Packet Guide

BAR 20-09-04

128 Chancellor Street

Exterior alterations and addition

BAR Comment Responses

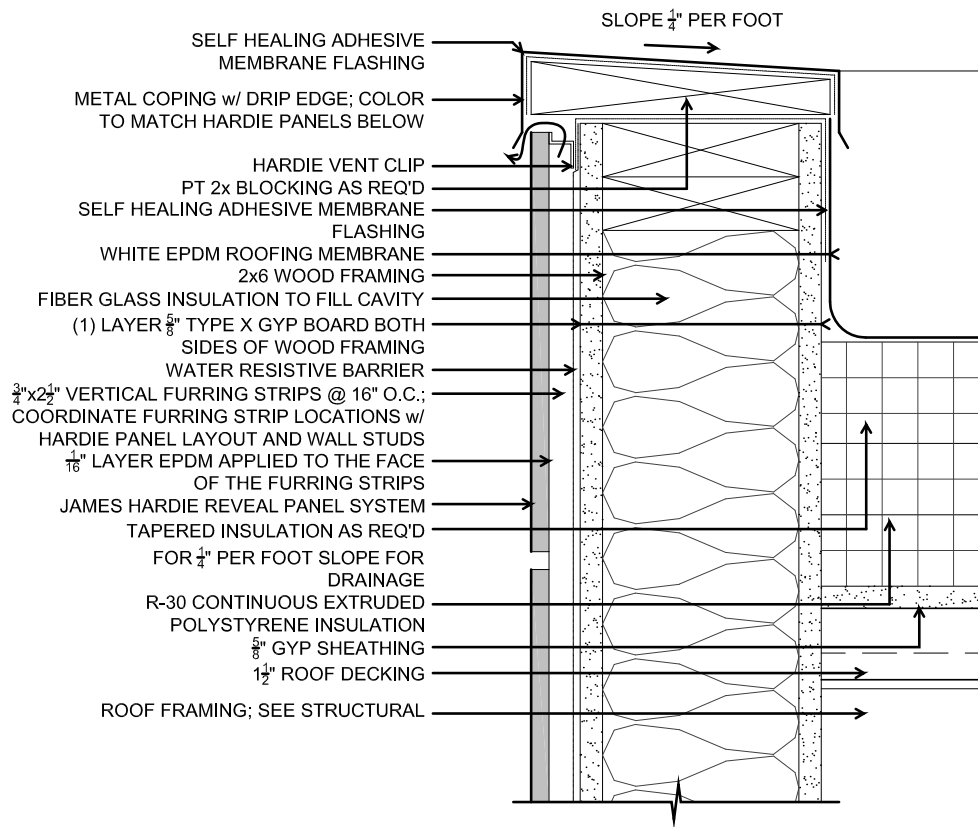
- 1) Roofing [at addition]: See outline exterior material specification.
- 2) Gutters/Downspouts: See outline exterior material specification.
- 3) Cornice: Capped parapet wall. See outline exterior material specification and attached supplemental drawings for additional information.
